**Florida
Power**
CORPORATION

October 2, 1979

SUBJECT: Crystal River Unit 3
Docket No. 50-302
Operating License No. DPR-72

On September 19, 1979, Florida Power Corporation received your letter dated September 7, 1979 requesting additional information concerning the upgrade of the anticipatory reactor trips on turbine trip or loss of main feedwater at Crystal River Unit 3.

RPS TRIP ON TURBINE TRIP
(SIMPLIFIED) Figure 2

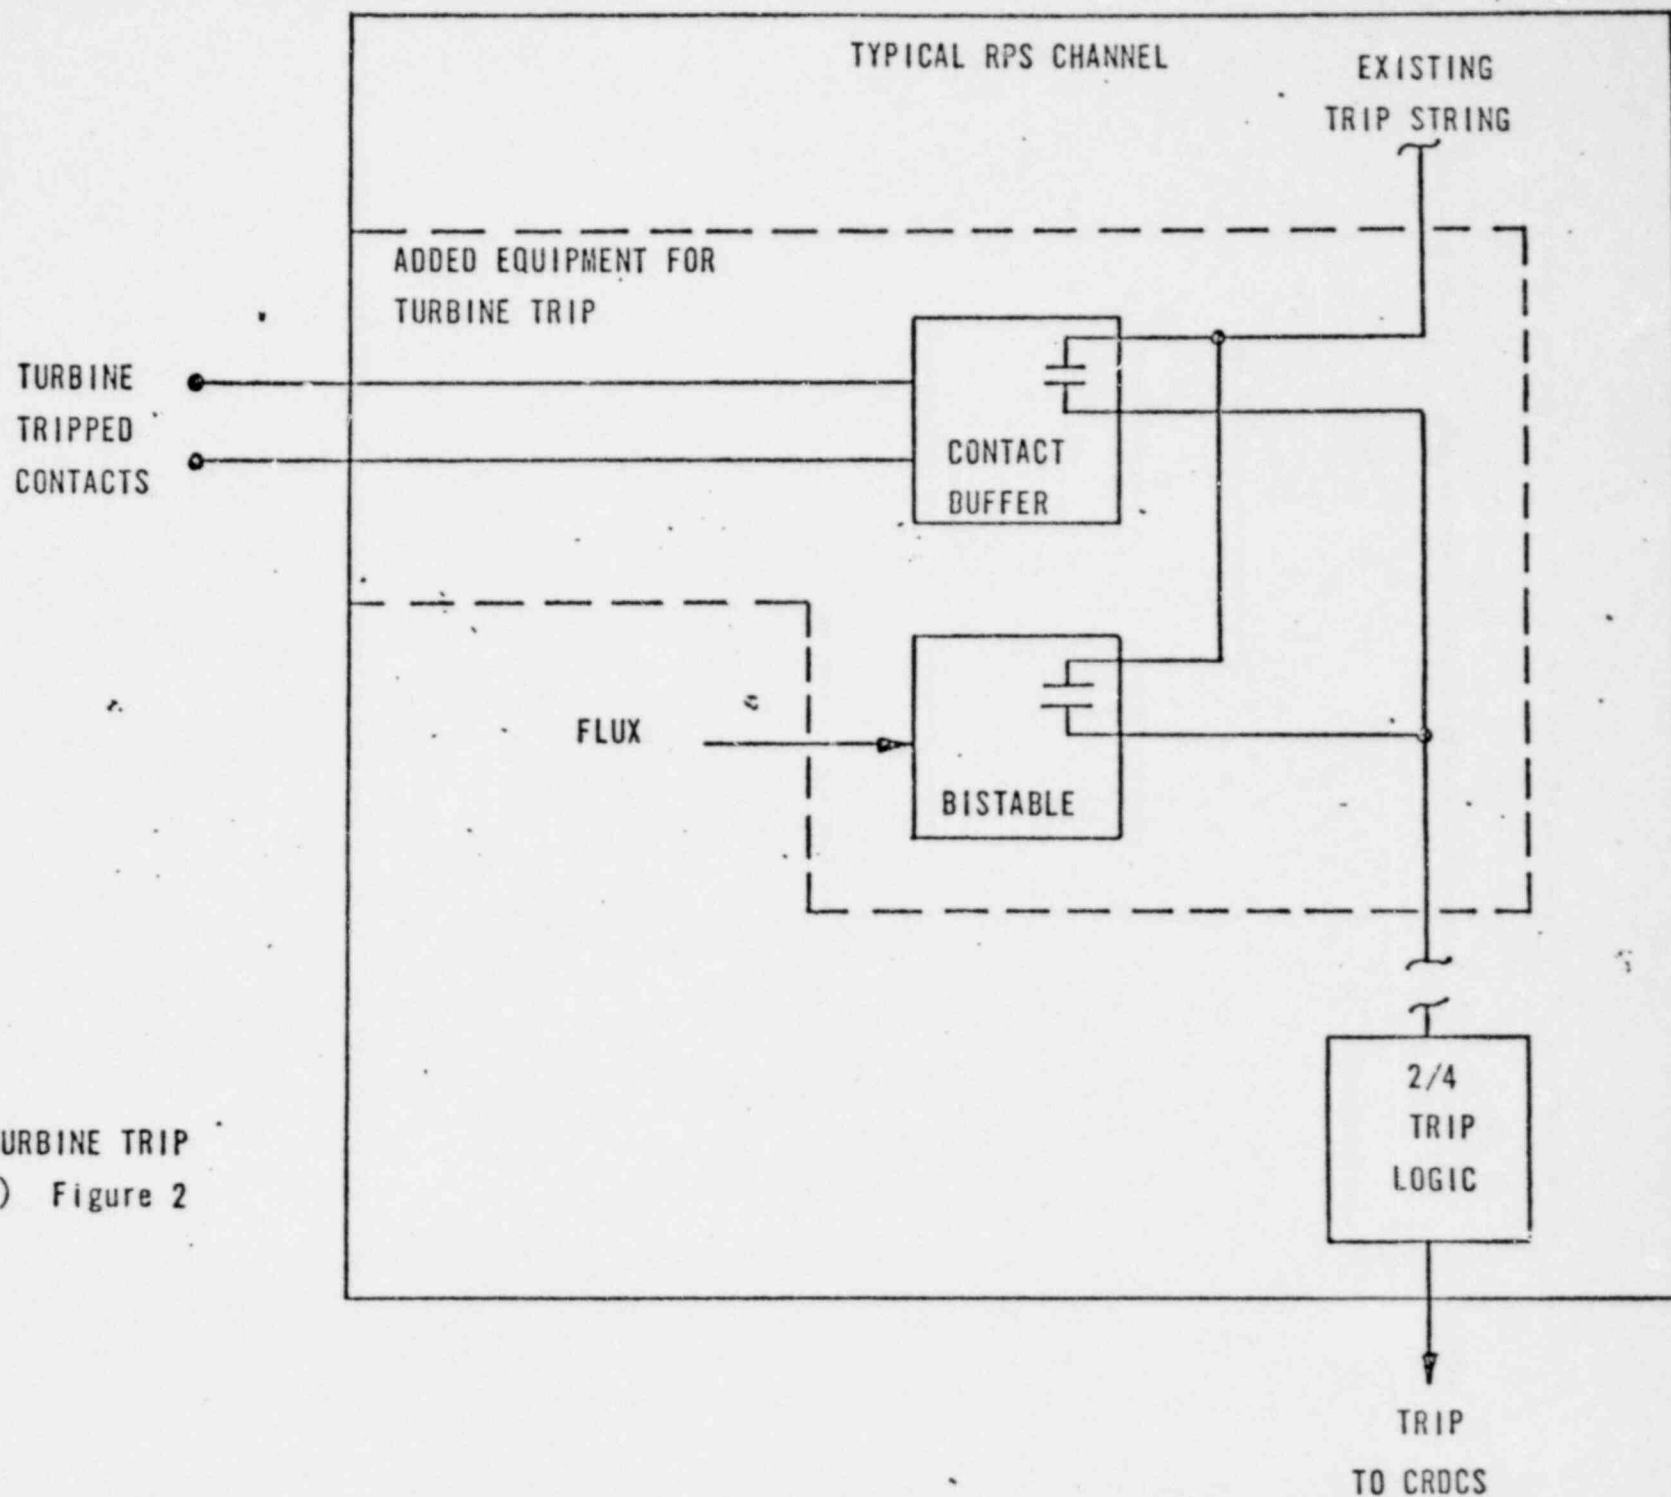
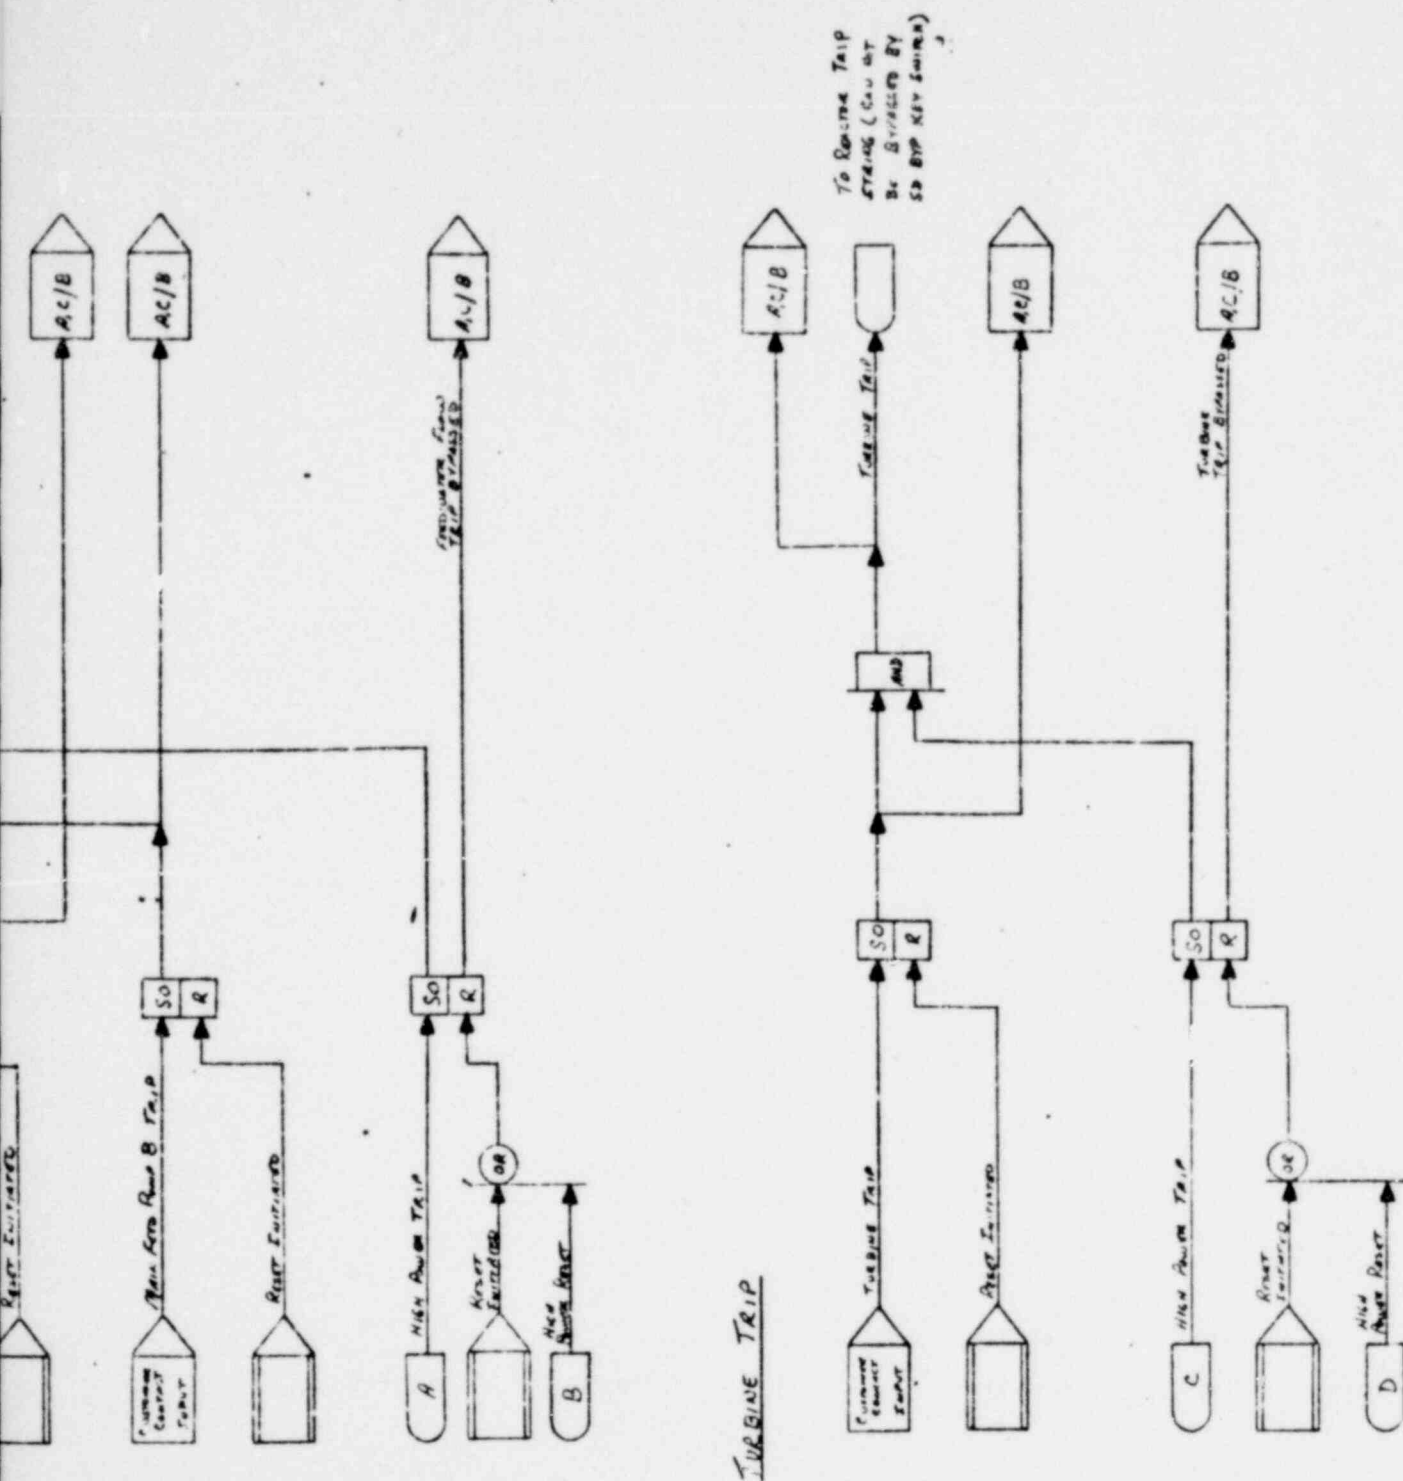
QUESTION 3. Provide a description of any changes to and/or interfaces with the existing protection system. Include diagrams (block, location, functional and/or elementary wiring), as necessary, to clearly depict the changes and/or interfaces. In addition, provide an analysis which demonstrates that these changes and/or interfaces will not degrade the existing protection system.

The anticipatory trip equipment will be added to the RPS cabinets and will interface as new trips in the present bistable trip string. Figures 1 and 2 of the Attachment I show the functional interface of the added equipment with the RPS. Drawings 51079DBG-1 and 51079MLG-1 of the attachment describe the inputs, outputs, and logic of the new trip functions. The added modules will consist of contact buffers, bistables, and auxiliary relays, which have been tested and qualified for use in the safety system. Existing RPS power supplies, flux signals, interlock circuits, and indicators will be used as required by the added equipment. The requirements for the RPS, e.g., cooling, power, seismic, environmental, will be the same for the system with anticipatory trips as the requirements prior to addition of the new trips.

Turbine Trip - Contact outputs from the main turbine electro-hydraulic control unit will input an open indication to the RPS on turbine trip. Contact buffers in the RPS will sense the contact inputs and initiate an RPS trip when a turbine trip is indicated. This trip will be bypassed below a predetermined flux level, typically 20% FP. Reference Figure 2.

FIGURE 9a-1

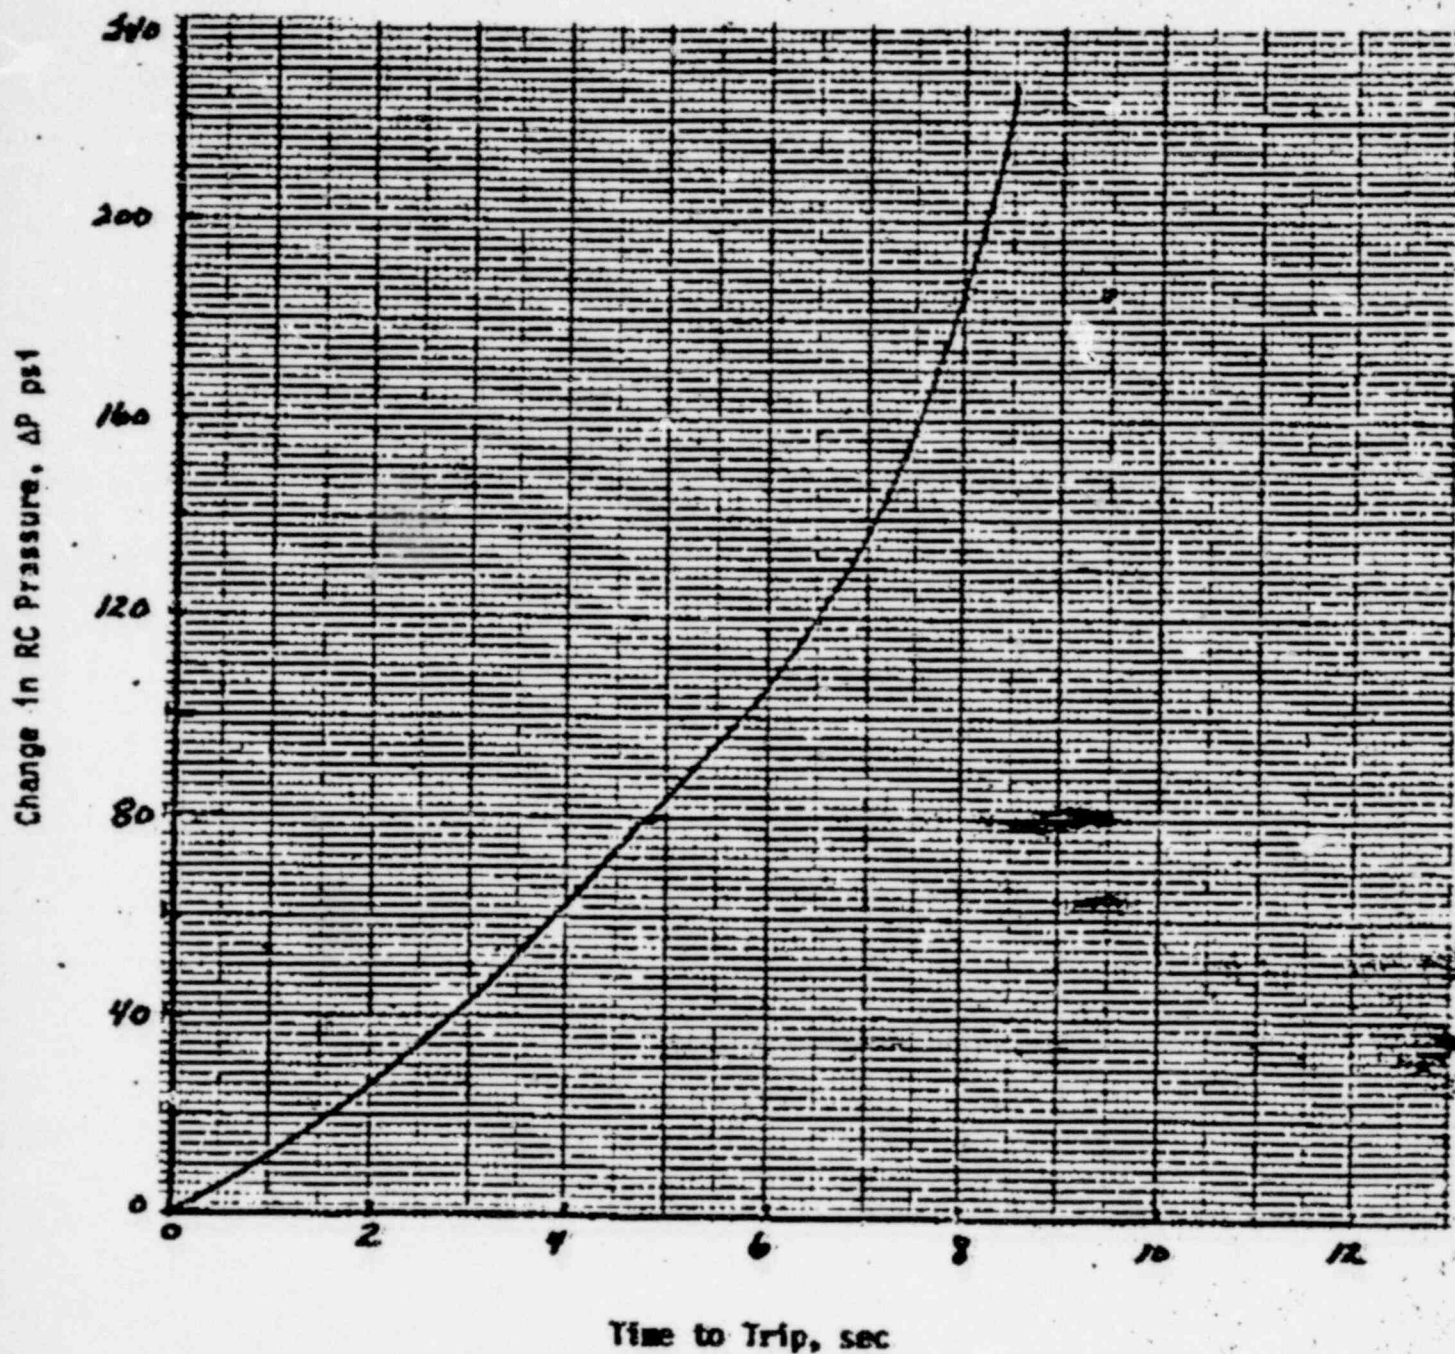
- a. Provide an analysis that quantifies the improvement in the time-to-reactor-trip for both the turbine trip and the loss of main feedwater signals;
- b. Address the need to bypass these trips at 20% power versus bypass at a lower power (approximately 10%);
- c. Discuss the adequacy of the proposed trip signals for loss of main feedwater for a variety of failure scenarios (such as feedwater valve closures), i.e., see the Oconee 1 transients of 6/11/79; and
- d. Provide an evaluation of why a reactor trip on low steam generator level is not a viable anticipatory trip signal when the other signals are bypassed, i.e., see the Crystal River 3 transient of 8/2/79.

- a. The primary purpose of anticipatory reactors trips (ARTs) is to reduce the probability of lifting the PORV for turbine trip/loss of main feedwater type events. For a reactor high pressure trip setpoint of 2300 psig, it was shown in References 1 and 2 that the PORV would not lift with a setpoint of >2400 psig. The margin to the PORV setpoint can be increased, however, by use of ARTs. Figure 9a-1 shows the pressure increase from nominal operating pressure as a function of time to trip for the loss of main feedwater event. From this figure, it can be seen that an ART that detects and trips the plant at 4 seconds results in a peak pressure increase of 60 psi; whereas the high R.C. pressure trip which would occur at 8 seconds results in a peak pressure increase of 184 psi. The anticipatory trip signals which have been selected will initiate a reactor trip in less than one second. As seen on Figure 9a-1, a one second time to trip results in a 12 psi pressure increase, compared to a 184 psi pressure increase for the high pressure trip at 8 seconds.
